HIGHLAND CITY DEVELOPMENT ADMINISTRATION BOARD AGENDA

DEVELOPMENT ADMINISTRATION BOARD AGENDA REPORT ITEM #1

DATE: October 10, 2024
TO: Development Administration Board
FROM: Rob Patterson, City Attorney / Planning & Zoning Administrator
SUBJECT: **Final Plat Approval:** Foxwood Estates
TYPE: **LAND USE (ADMINISTRATIVE)**

ATTACHMENT 6

Scale: 1"=20'
Date: 09/09/24
Sheet: PP04

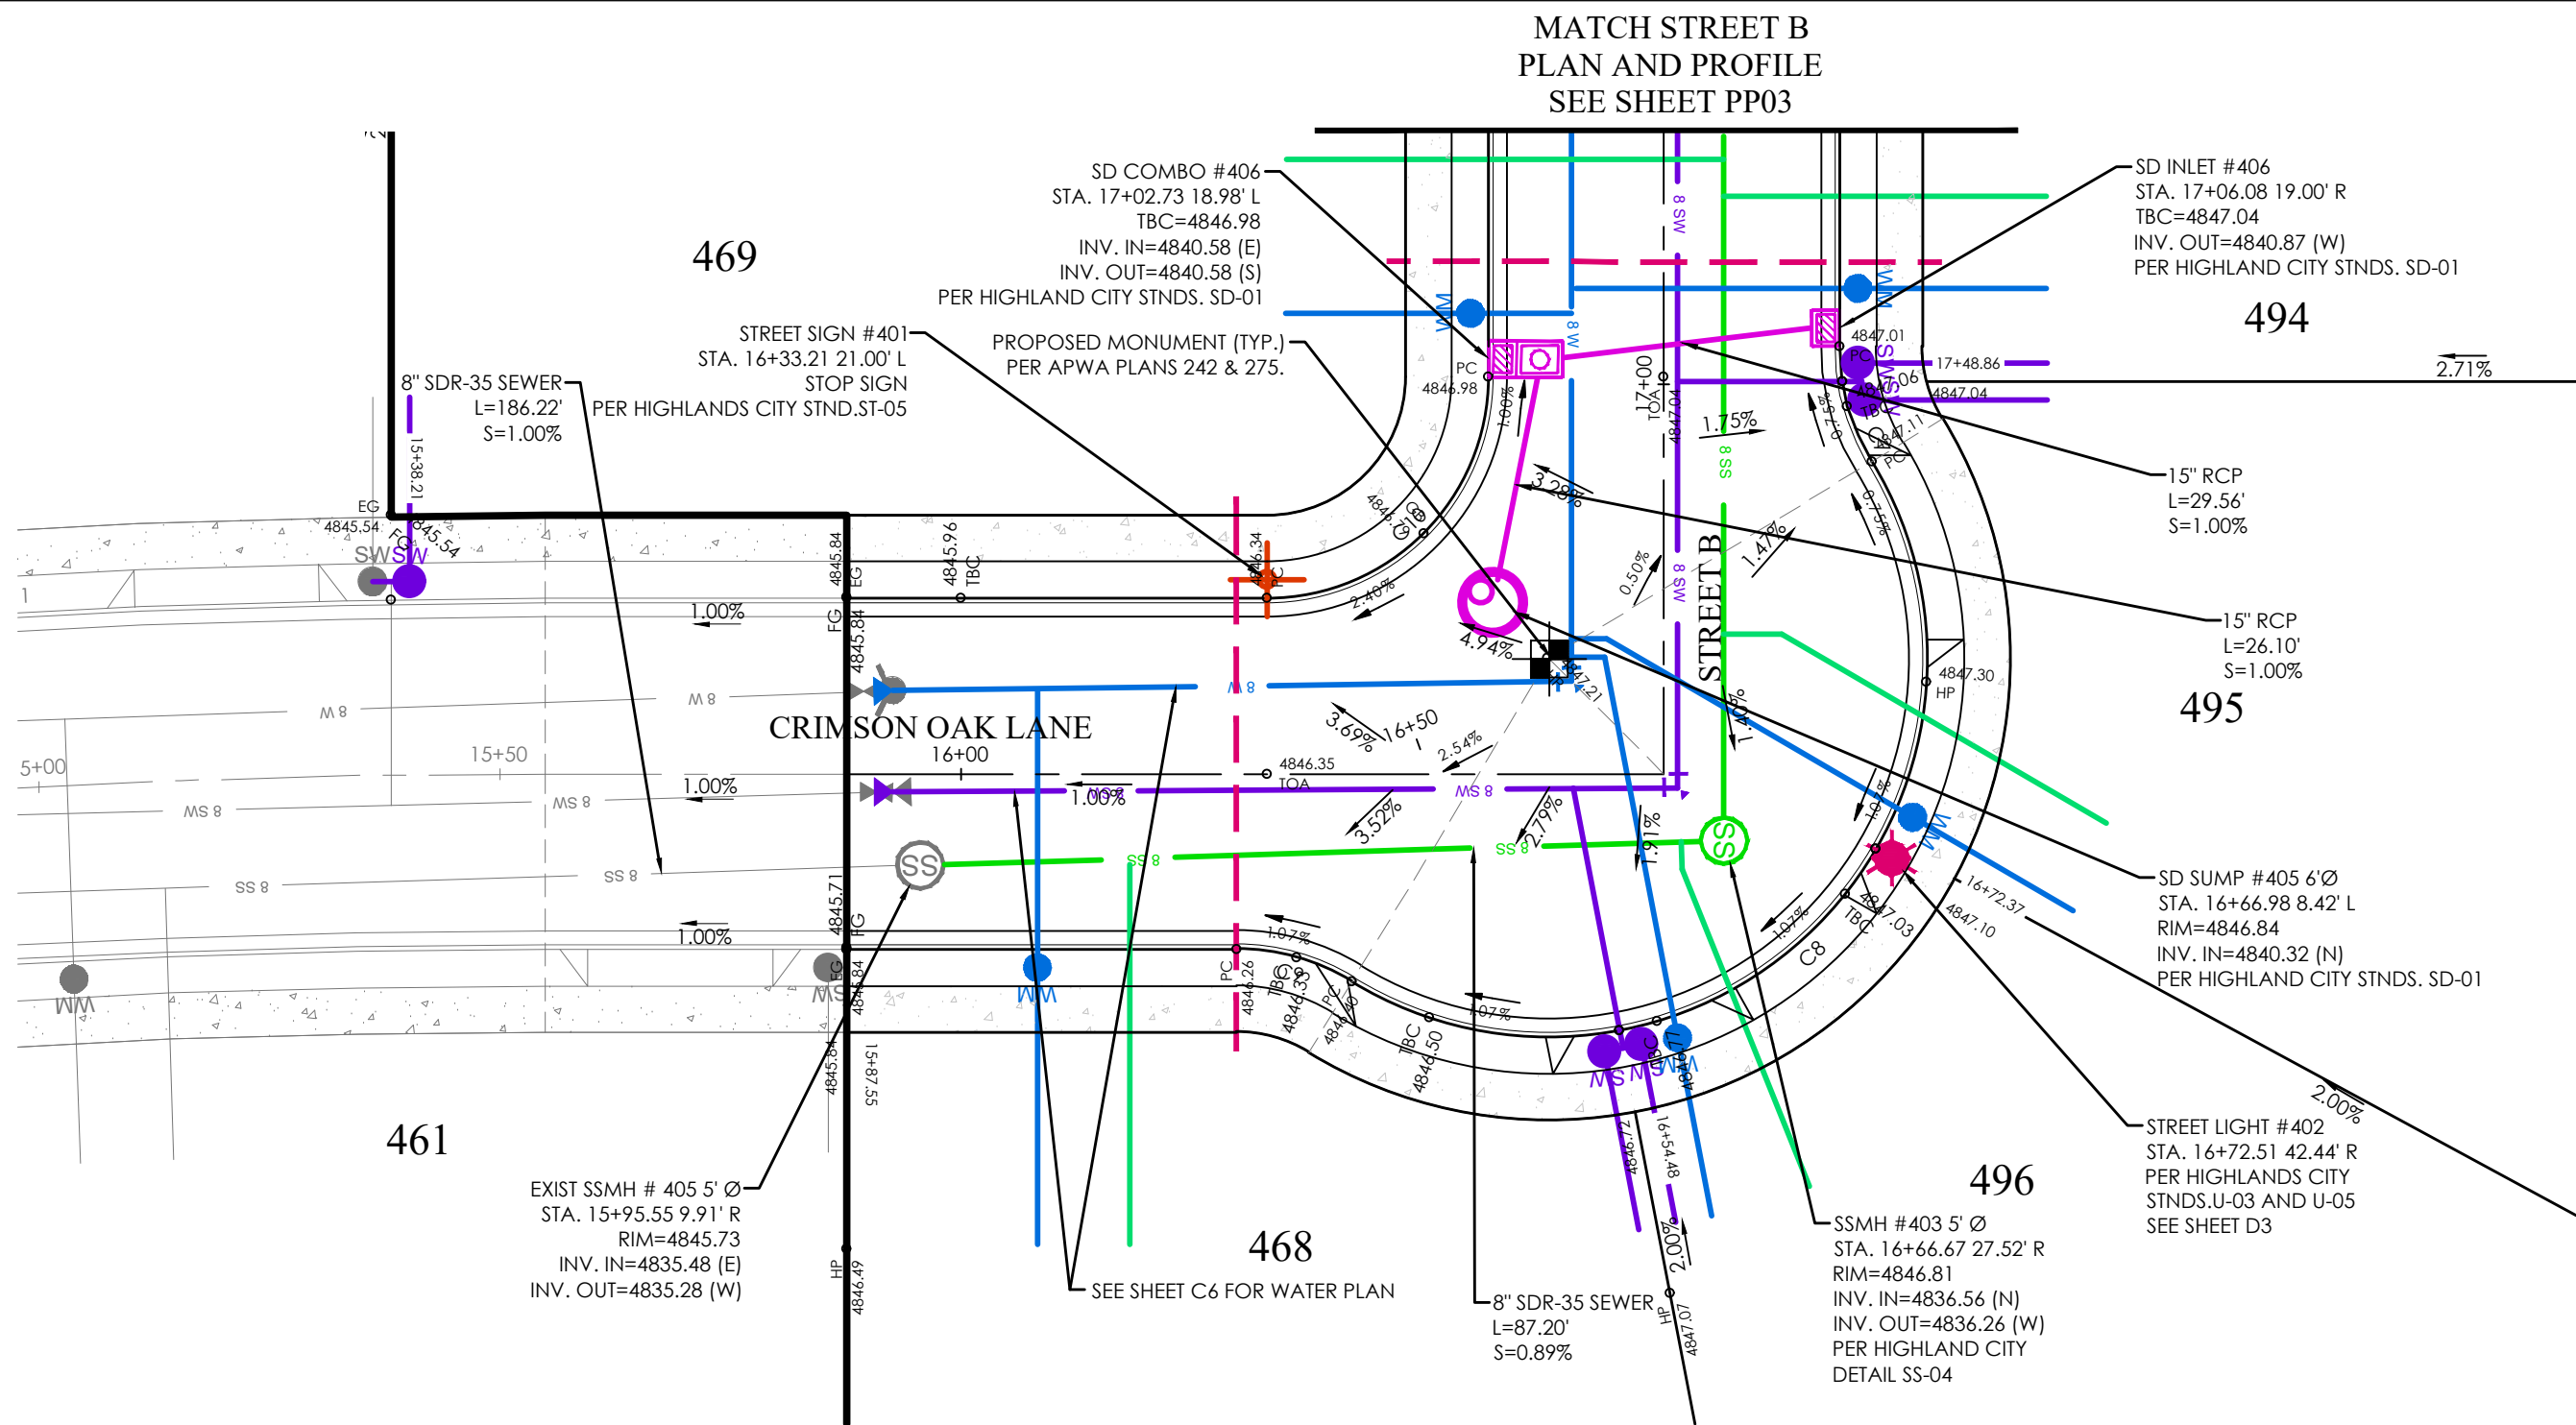
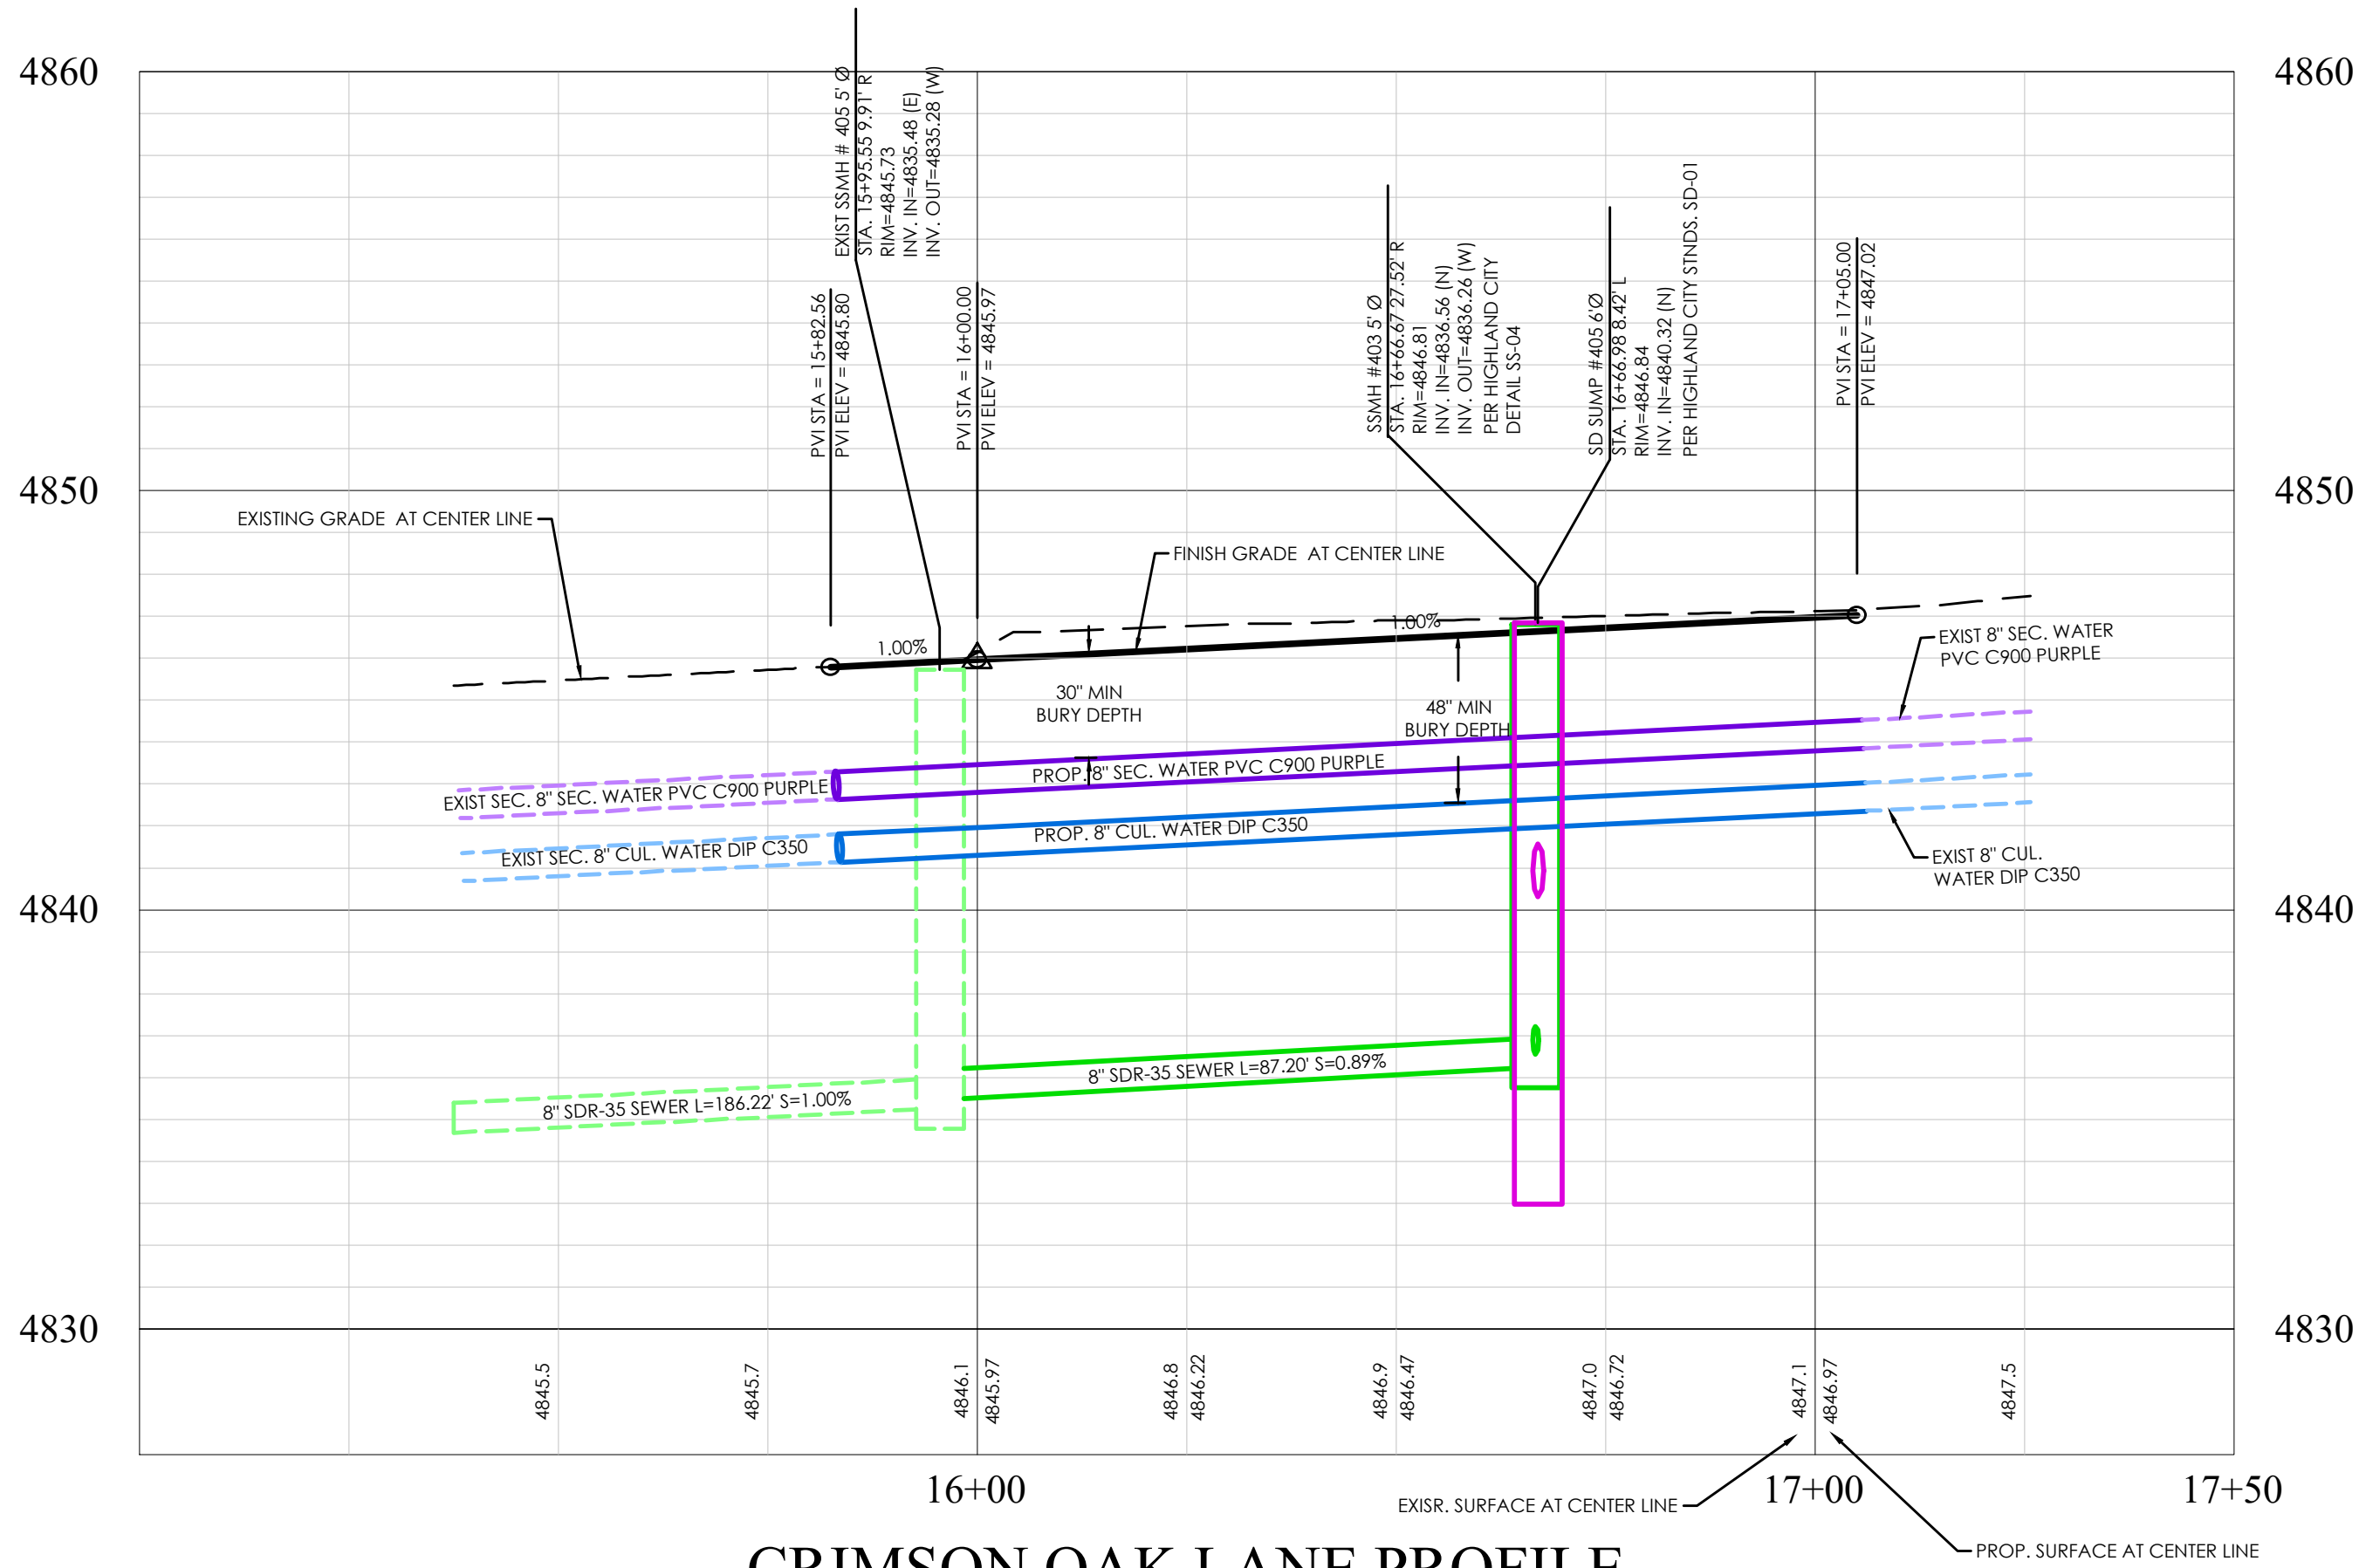
4. Green Ash Lane/Street B, Sheets PP01, PP02, PP03: Remove "Street B" from match lines and from plan views.
5. Crimson Oak Lane, Street Monument, Sheet PP04: Please provide reasoning for the location of the street monument. It does not mark the intersection of the two streets.
